# Technical Service Bulletin

**MODEL(S) AFFECTED:** **Speed Scrub 500 (SS500) Walk-behind Scrubber**

**SUBJECT:** Potential drive wheel mounting hardware issue. The axle nut may back off and cause the wheel to become loose and possibly damage wheel and axle.

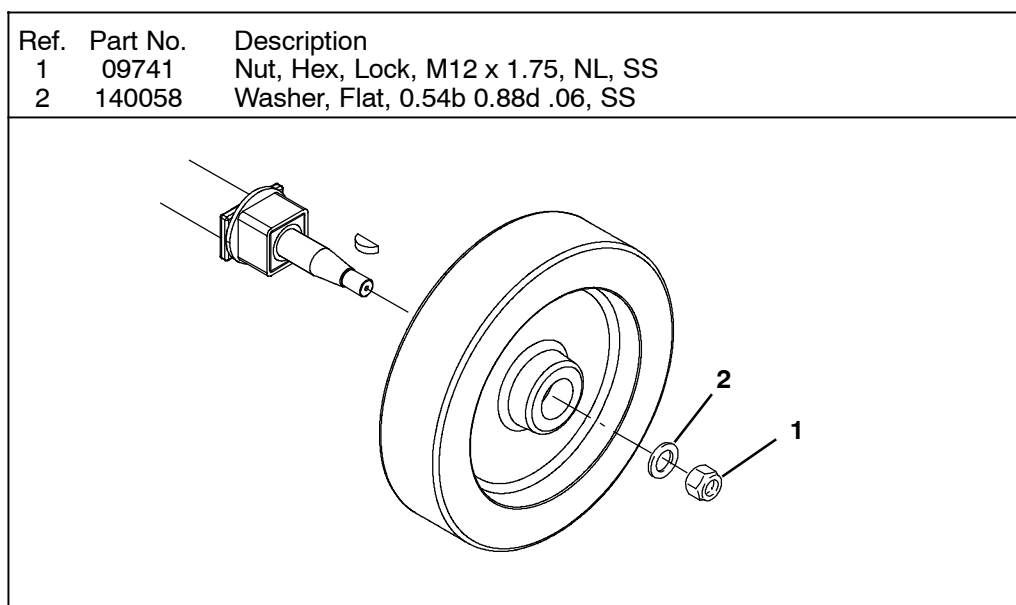
**PURPOSE:** To prevent axle nut from backing off, install improved hardware listed below.

Maximum torque 24 Nm/18 ft-lbs. Do not over tighten nut. Higher torques will deform the center of the wheel, compromising the conical fit to the transaxle.
